Access Compliance Report Public Rights-of-Way (Curb Ramps)

Main Street: **ESTES_WAY** Cross Street: **CARLSBAD_DR** Location: **SW**

ADA ID: **RPAT211019110322** Ramp Type: **Type 1 - Perpendicular Diagonal** Initial Pass/Fail: **Fail** Overall Compliance: **No** Severity Score: **15**

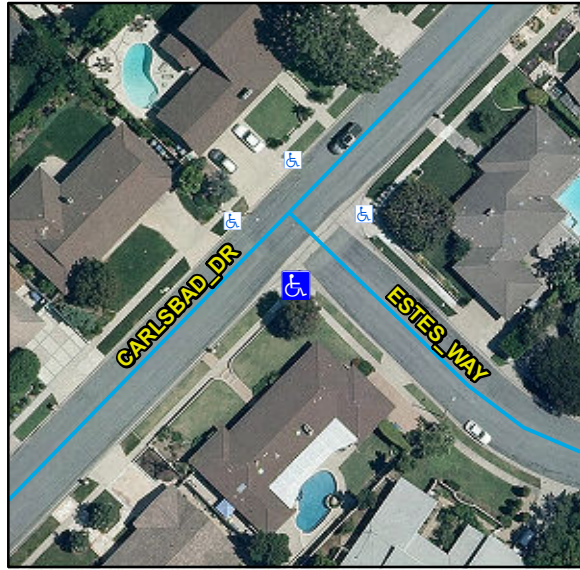
Compliance	Description	Data	Compliance	Description	Data
N/A	Ramp Length (in)	109	N/A	Flare Type LT	
Yes	Ramp Width (in)	55			N/A
Yes	Ramp Run Slope (%)	7.3	N/A	Flare Slope LT (%)	N/A
No	Ramp Cross Slope (%)	6.8	N/A	Flare Traversable LT	N/A
N/A	Landing Present	N/A	N/A	Flare Type RT	
N/A	Landing Length (in)	N/A			N/A
N/A	Landing Width (in)	N/A	N/A	Flare Slope RT (%)	N/A
N/A	Landing Run Slope (%)	N/A	N/A	Flare Traversable RT	N/A
N/A	Landing Cross Slope (%)	N/A	N/A	DWS Provided	N/A
N/A	Landing Movement Obstructed?	N/A	N/A	DWS Contrast	N/A
	Landing Movement Type	N/A	N/A	DWS Length (in)	N/A
N/A	Landing Shared	N/A	N/A	DWS Full Width	N/A
N/A	Clear Space	Yes	N/A	DWS Offset Left (in)	N/A
N/A	Clear Space To Crosswalk (in)	N/A	N/A	DWS Offset Right (in)	N/A
N/A	Marked Crosswalk 1	No	N/A	Marked Crosswalk 2	No
	Crossing 1 Direction	NE		Crossing 2 Direction	NW
	Marked Crosswalk 1 Width (in)	N/A		Marked Crosswalk 2 Width (in)	N/A

Remove & Replace Curb Ramp With Two New Directional Ramps or Equivalent.
